GROUP	MODEL
	Voluntary Emissions Service Campaign	2025MY Carnival (KA4)
	NUMBER	DATE
	SC333	June 2025
VOLUNTARY EMISSIONS SERVICE CAMPAIGN		
SUBJECT: ENGINE CONTROL MODULE LOGIC IMPROVEMENT (SC333)

This bulletin provides information to upgrade the 'Engine Control Module' (ECM) system software on certain 2025MY Carnival (KA4) vehicles equipped with 3.5L GDI Lambda III engines produced from April 15, 2024 through November 27, 2024. The subject vehicles may have been produced with engine calibration that may cause the vehicle to release air pollutants that exceed Federal and California standards and cause the illumination of the Malfunction Indicator Lamp (MIL) with DTC P046100. These standards were established to protect the public health and welfare from the dangers of air pollutants. To ensure compliance with emissions regulations, follow the procedure outlined in this publication to apply the improved logic to the 'Engine' system using the KDS ECU Upgrade function as described in this bulletin. Refer to [SST081](#) for software upgrade instructions using Kia Diagnostic System (KDS) tablet and VCI-II and confirm the Upgrade Event Number/Name, ROM ID Information, and Manual Mode pa

ENGINE CONTROL MODULE LOGIC IMPROVEMENT (SC333)**ROM ID Information Table:****Upgrade Event #806****❗ IMPORTANT**

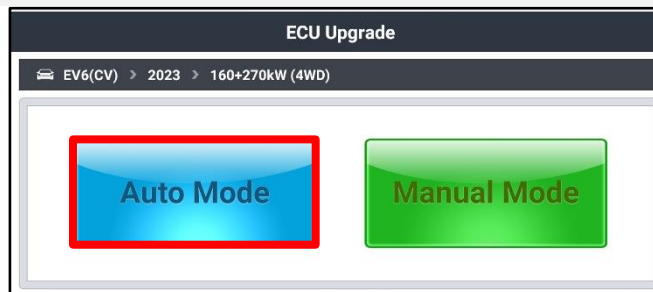
Comment	System	IMMO 	ECU P/No.	ROM ID	
				Previous	New
Without Sunroof	ECM	Yes - O	39110 3N825	GKA45NS0HQ000M03	GKA45NS0HQ100M03
With Sunroof			39110 3N835	GKA45NS0HQ000ML3	GKA45NS0HQ100ML3

To verify the vehicle is affected, be sure to check the Calibration Identification of the vehicle's ECM ROM ID and reference the Information Table as necessary.
